## **Summary of NCSX Response to Recommendations from the Physics Validation Review Pertaining to Design and Fabrication**

*from Charge #1: Comment on the progress made by the project to address and resolve the comments from the PVR pertaining to NCSX design and fabrication.*

A Physics Validation Review (PVR) of NCSX was held in March, 2001. The very positive PVR panel report contained 29 recommendations addressing issues of design, research planning, and program management. Following the PVR, the project and the Department of Energy prepared a disposition plan for the PVR recommendations. The plan calls for those issues pertaining to the design and fabrication of NCSX to be resolved by the time of this Conceptual Design Review. Some of the PVR issues pertain to NCSX operation or stellarator development more broadly, or are of a programmatic or management nature. While these are not directly relevant to the design and fabrication of NCSX, the project responses are included here for completeness.

**Figure 6. NBI footprint (circles) for the most poorly focussed beam superimposed on the oblate plasma cross section. The larger circle encloses ~96% of the injected power, the smaller circle encloses 47%.**

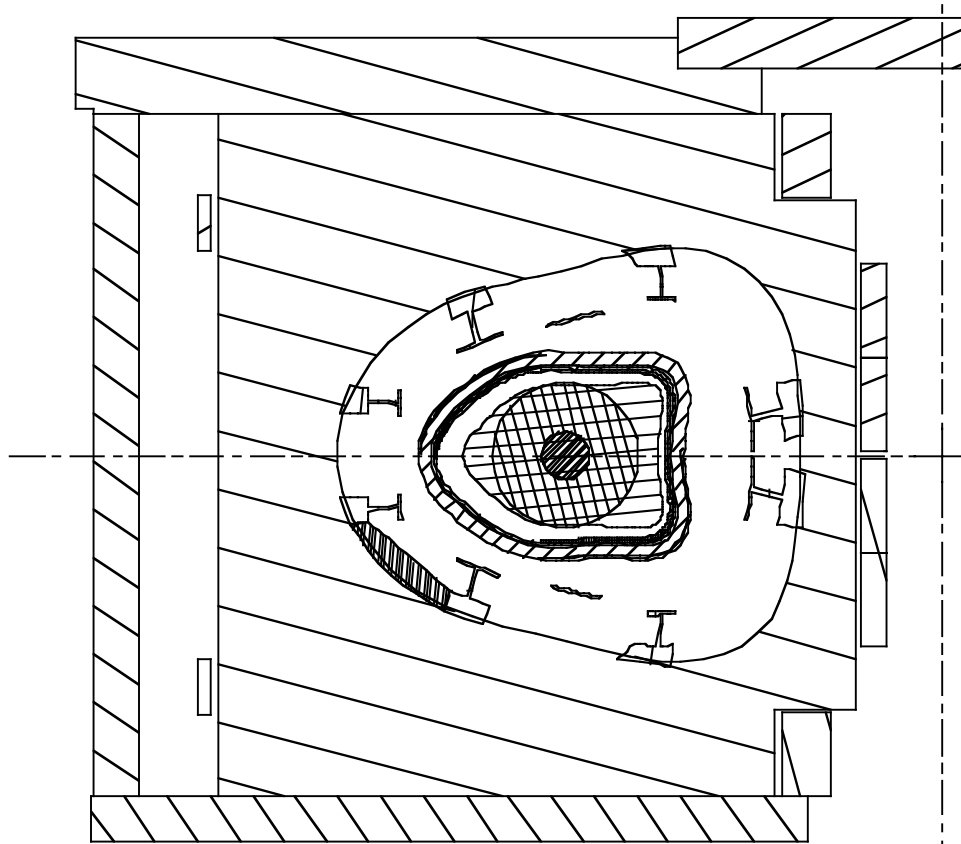
Neutral penetration was among the concerns expressed by the PVR panel in connection with size. The PVR panel recommended more extensive edge and neutrals modeling:

*PVR panel Recommendation IV-7:* The Panel recommends that, now that the general magnetic configuration has stabilized, an intensive investigation of the neutral penetration issue be carried out. This would involve detailed study of the 3-D field structure and application of existing edge physics models in appropriate frames of reference, and comparison with relevant experimental results, especially those from Wendelstein 7AS, which has a similar edge topology. The Panel notes that this project would be an excellent target for expanded collaboration with the US edge physics and stellarator community as well as with overseas stellarator programs.

The neutral beam optics has been modeled for the PBX neutral beams in the NCSX geometry. The modeling uses the measured PBX beam characteristics as input. The beam "footprint" size is not small compared to the plasma cross section, as shown in the following figure, but does enclose ~96% of the injected power from the most poorly focussed beam. The geometrical modeling supports the conclusion that the  $R = 1.4$  machine size is adequate, although marginal and likely to be limited in aiming flexibility.
